ADDENDUM 2

LSD Dwight Rich Food Service Bid Pack 1, Addendum No. 2

Project Name:	Dwight Rich Food Service – Equipment Replacement & Renovation	Date:	March 4, 2026
Project Location:	2600 Hampden, Lansing, MI 48911	Architect's Project #:	25015928A
Owner/Client:	Lansing School District	Attention:	David Beckering
Issued to:	Beckering Construction	Email:	djb@beckering.com
City/State:	Grand Rapids, MI	Zip:	49548

FSE-1

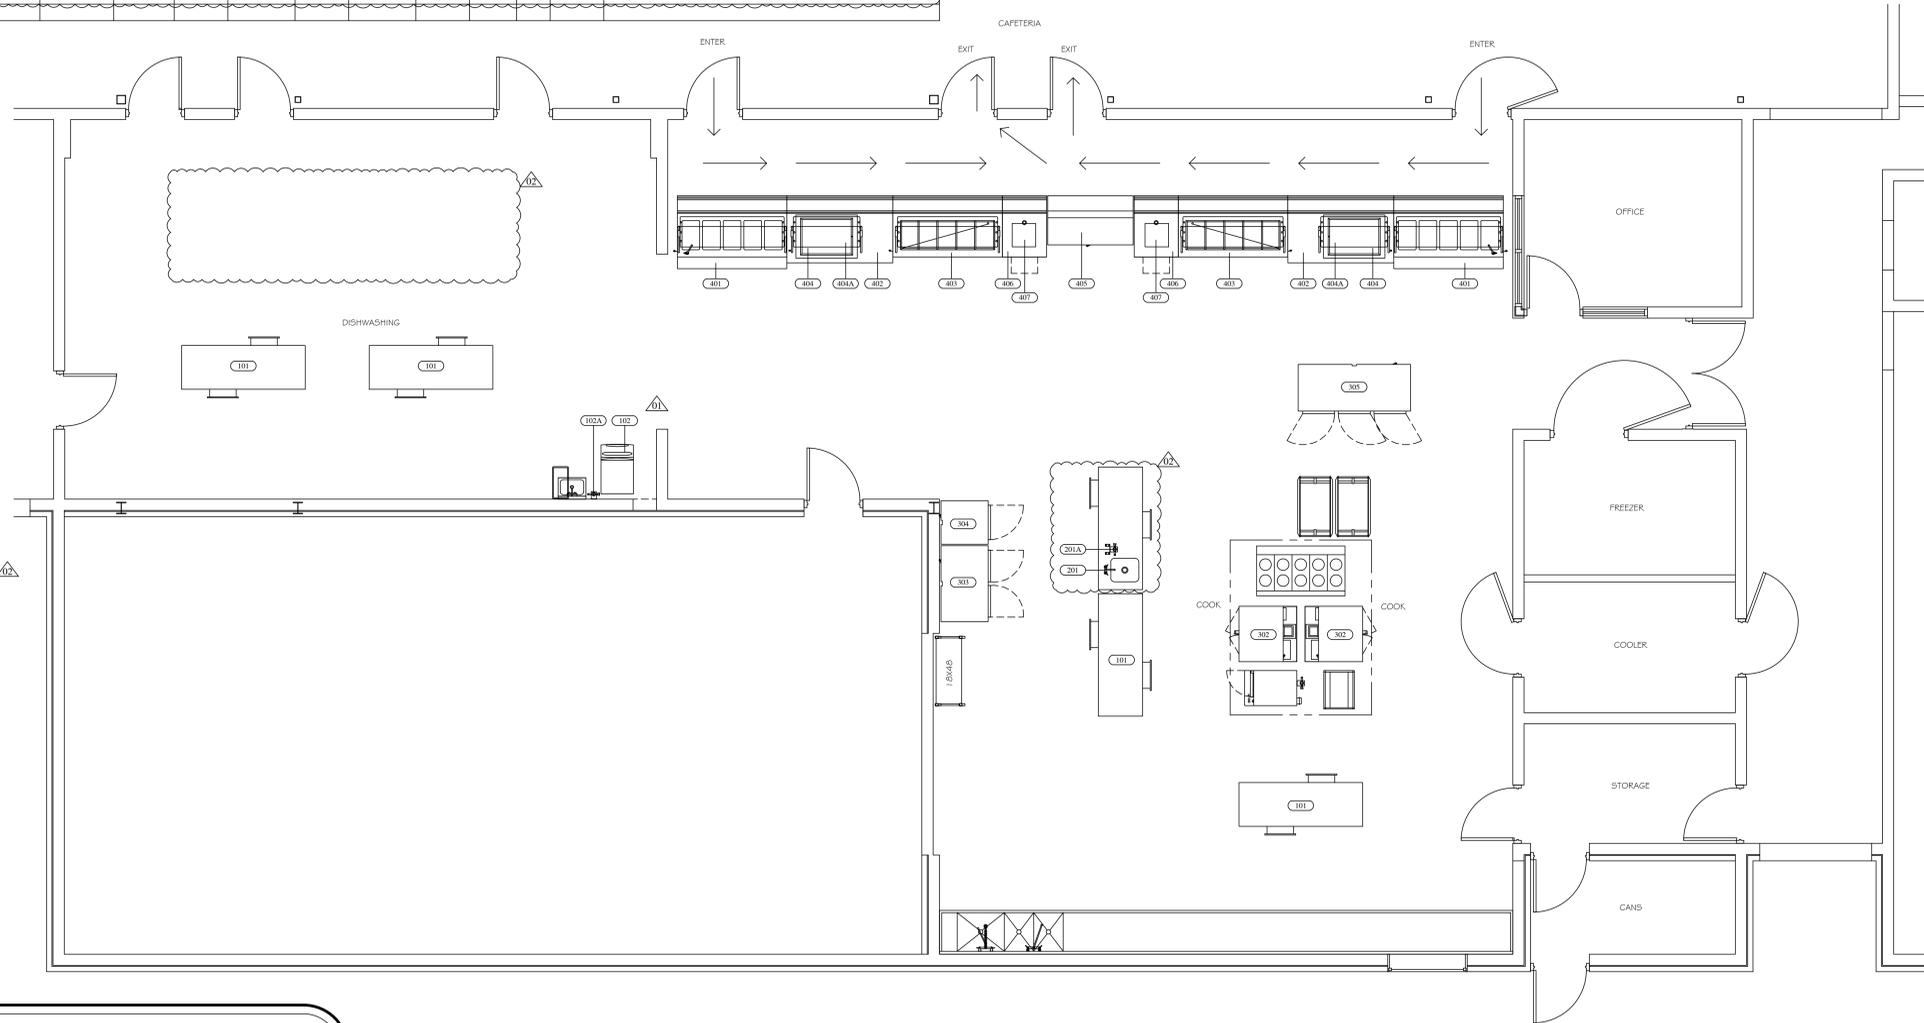
- Sheet FSE-1 is being reissued.
- Item #104 – Portable Table – Qty. of 5 – Quantity should be a Qty. of 4 in lieu of a Qty. of 5.
- Item #202 – Cook’s Table - Qty. of 1 – Should be listed as Item #201 on the plans and in the specifications.

- Item #202A – Cook’s Table Filter - Qty. of 1 – Should be listed as Item #201A on the plans and in the specifications.
- Item #502 - Disposer - Qty. of 1 – Unit has been removed from the scope of work.

- Item #503 - Dishwasher Hood – Qty. of 1 – Unit has been removed from the scope of work.
- Item #504 - Clean Dish Table - Qty. of 1 – Unit has been removed from the scope of work.

- Item #504A - Soiled Dish Table - Qty. of 1 – Unit has been removed from the scope of work.
- Item #505 – Water Softener & Filtration- Qty. of 1 – Unit has been removed from the scope of work.

- Item #506 – Dishwasher – Qty. of 1 – Unit has been removed from the scope of work.
- Item #506A – Drain Water Tempering Kit – Qty. of 1 – Unit has been removed from the scope of work.
